# Addendum to a section 42A report for Proposed Private Plan Change 85: 48 Esmonde Road, Takapuna to the Auckland Unitary Plan (Operative in Part)

**Addendum Author:** Vanessa Wilkinson, Consultant Planner, Scott Wilkinson Planning for Plans and Places, Auckland Council

**Addendum produced:** 28 April 2023

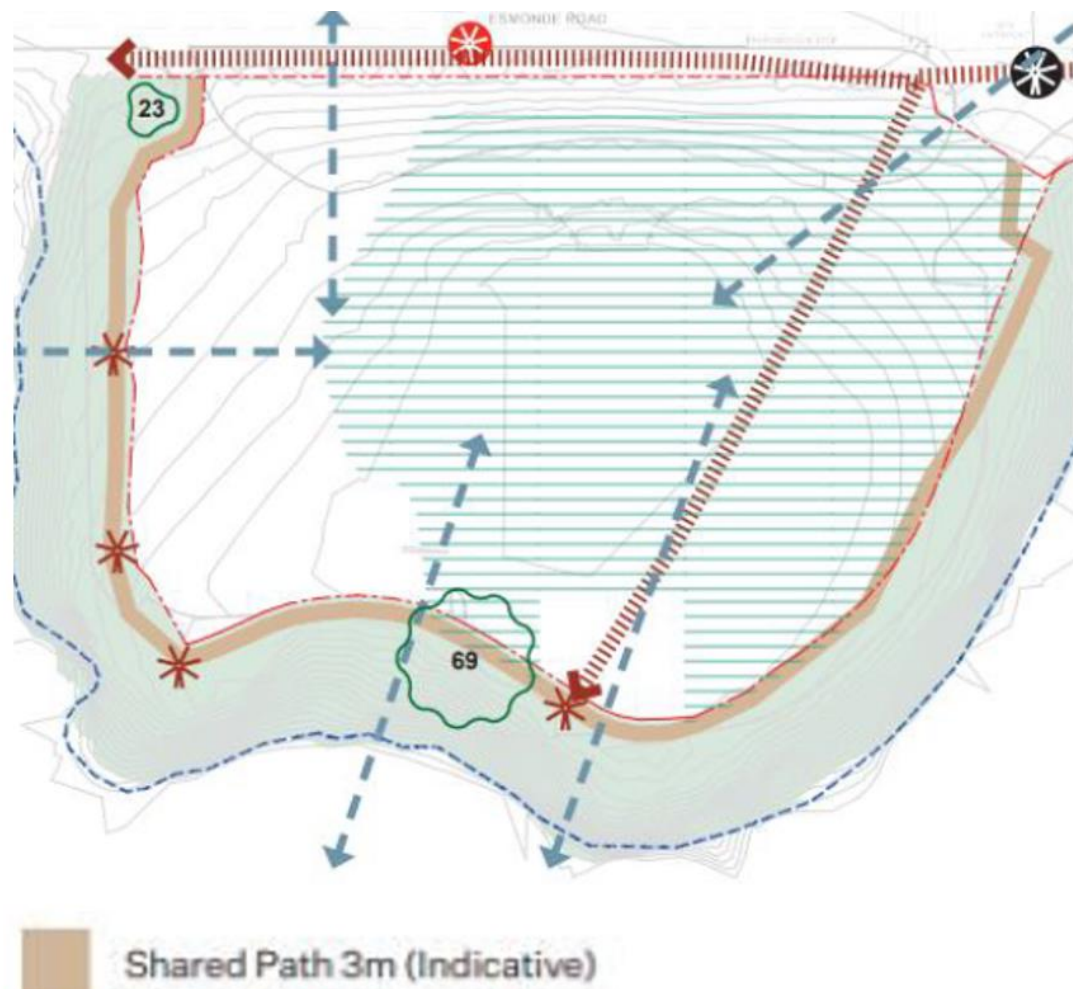
This provision is also well intended but only refers to Engineering approval and does not include Arboricultural or Ecological considerations. This needs to be further considered and amended to include both Arboricultural and Ecological assessments and approval of effects of the walkway design, particularly as the proposed walkway depicted on the site features plan (pasted below) passes directly through the root zone of tree 69 – and no doubt numerous other trees located within the proposed OSCZ.

Figure 2 – Amendment to the esplanade reserve / Open Space – Conservation Zone boundary

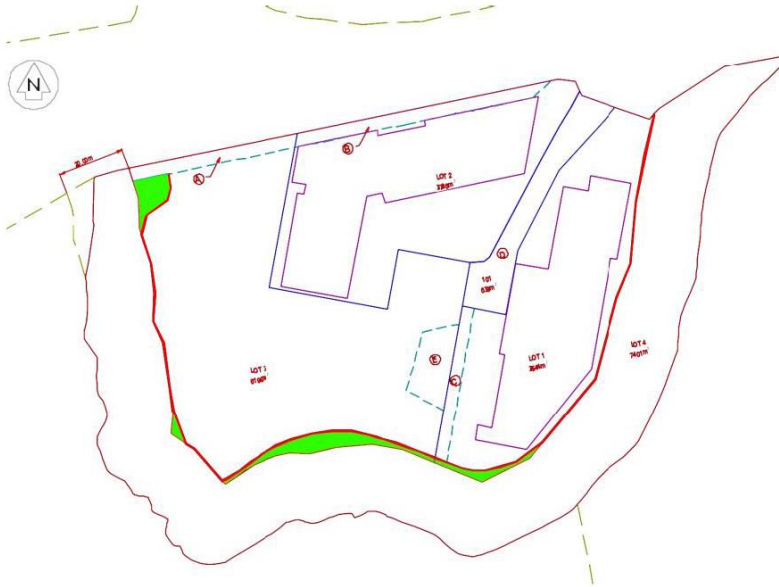
66. The amendment to the proposed OSCZ boundary is shown on Figure 2 in the applicant's planning evidence. Copied below.

67. Due to uncertainty about the adequacy of the area proposed for the shared path it is uncertain if the amendment to the OSCZ zone will accommodate the shared path and viewing platforms. Following feasibility analysis, the OSZC should be increased in size as necessary to provide for a well-designed shared path, viewing platforms, ancillary structures and landscaping.

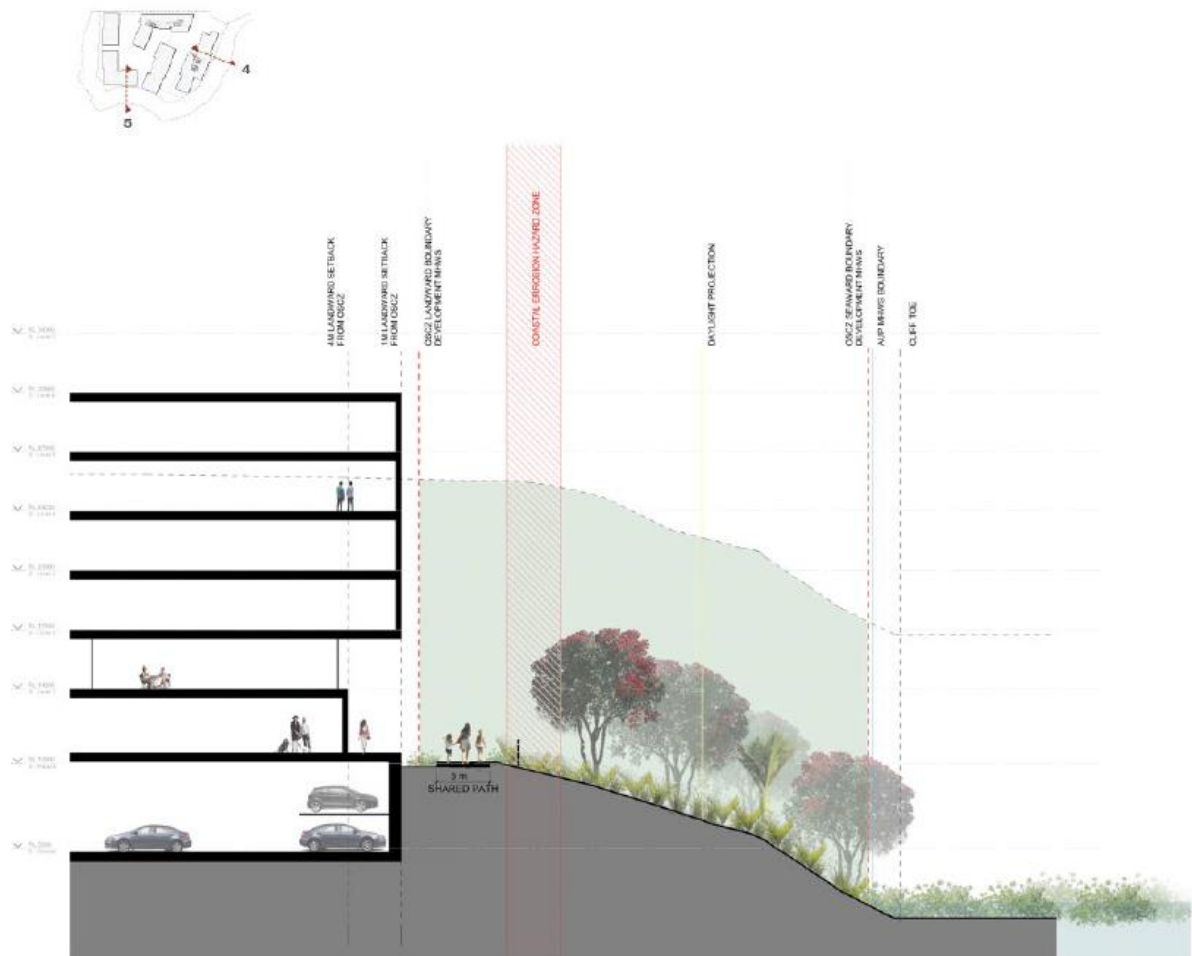
73. An excerpt from approved drawing LUC60359471 North Elevation (RC-300 Rev. C) is copied below with a person added in the centre to estimate the relative human scale.

74. Due to the distance between the building and people in the walkway being relatively narrow I consider that people will experience the buildings to be very dominant, although this would be partly mitigated due to views available to the coastal margin and beyond. In the afternoon, the eastern pathway will be completely shaded.
75. The applicant's urban design evidence provides an assessment of the amenity of coastal shared path / interface with buildings (paras. 57 – 61) supported by a cross-section drawing of the eastern elevation, copied below.

Section 5 - South interface

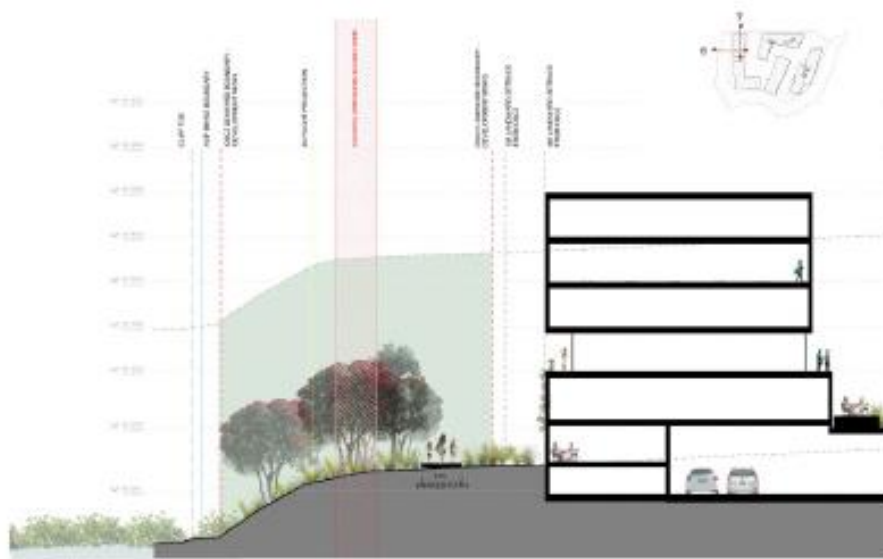
102. In terms of assessing the potential dominance effects on people using the shared pathway caused by potential buildings, the applicant's urban design evidence provides cross-sections of the south and western interfaces.
103. The South interface cross section copied, modified (in red) to show the second level extending to the permitted one metre setback from the OSCZ boundary:

104. The drawing is a cross section of a hypothetical building developed as permitted by the standard. It demonstrates that the shared path will be located close the building. In my opinion, the building will be experienced as a very dominant structure for users of the pathway. The 4-metre setback at the first floor will have only a marginal benefit compared to if it were not required, and the bulk of the building above will remain dominant.
105. As previously noted, the 6-metre setback at 19-metres tall has not been shown on the drawing.
106. West interface cross section copied below:

Section 6 - West interface

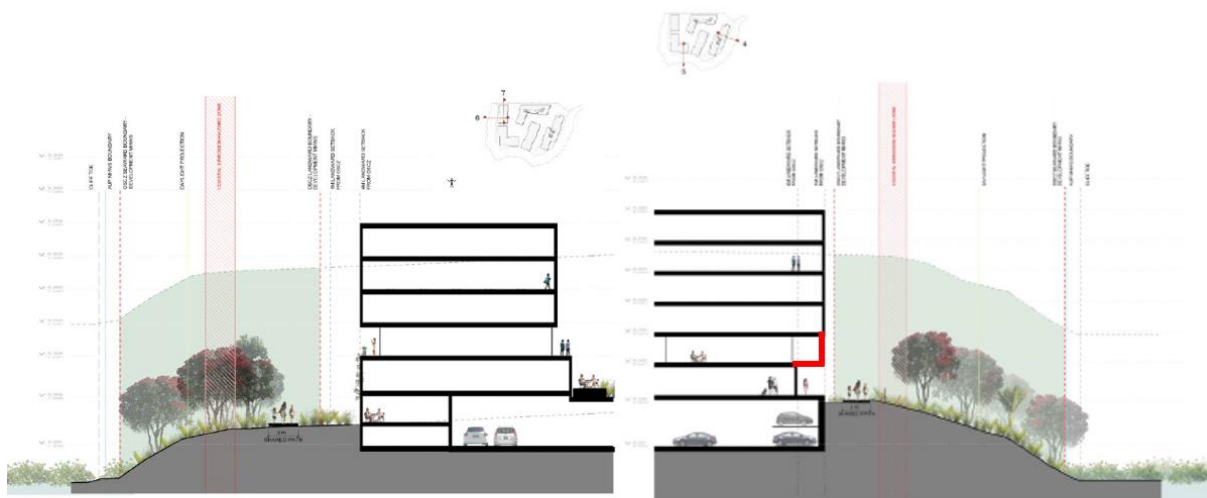
107. The drawing is a cross section of a hypothetical building set back 4 metres from the OSCZ (i.e., not set back by the one metre permitted by the standard). It does represent the building as would be permitted by the standard. Nevertheless, when compared, the drawings provide an opportunity to observe the difference in outcomes on the OSCZ. Composite copied below.

### **The publicly accessible through route**

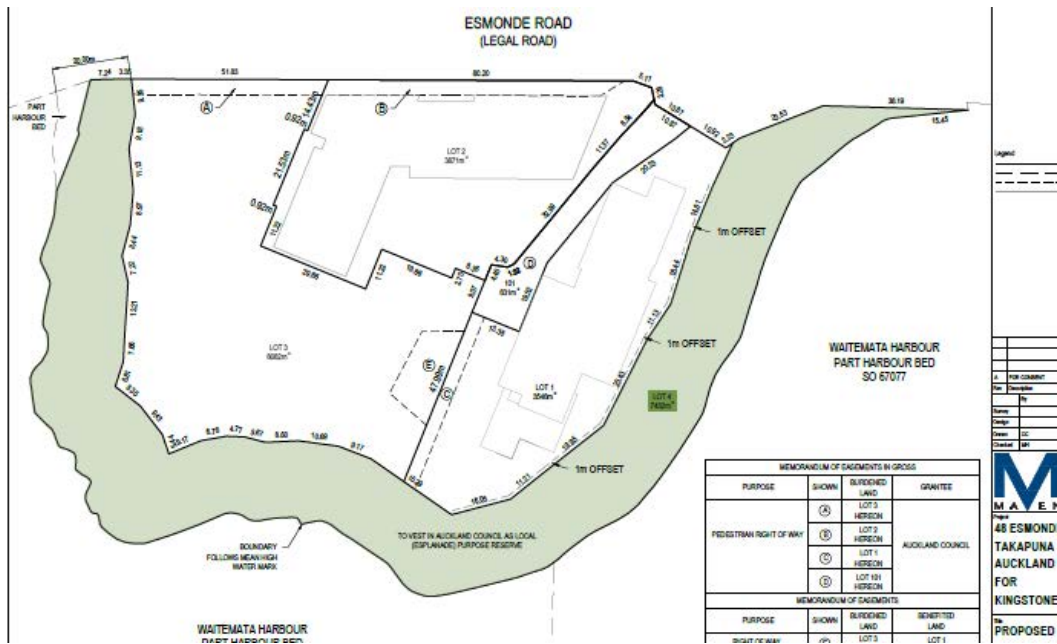
122. PPC-85 does not specifically show on a plan the publicly accessible open space amenity areas throughout the Precinct or the route to the OSCZ. The background Masterplan, as copied in applicant’s Urban Design, report shows the Precinct Plan 1 route overlaid with a ground level landscape arrangement. Copied below.

123. The pedestrian/cycle connection is located through raised planters and through vehicle accesses. The route is broadly indicative and not accurate. I consider that an accurate route location is required to ensure the actual route is protected by the proposed easement. The pedestrian/cycle route is not clearly defined even on the approved LUC drawings.

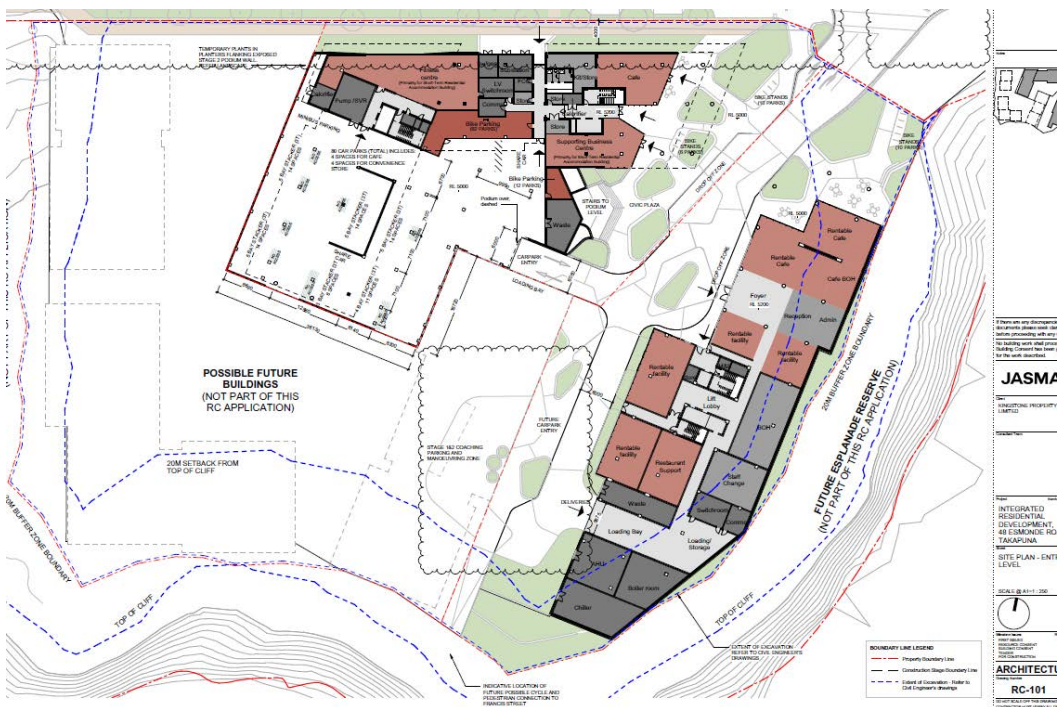
126. An excerpt from approved drawing LUC60359471 North Elevation (RC-101 Rev. C) is copied below:

127. The proposed easement does not show the raised planter beds or road carriageway which would both direct and affect safe pedestrian and cycle passage. Part 'C' is aligned against the future 'Ancillary' building and the carpark entrance.
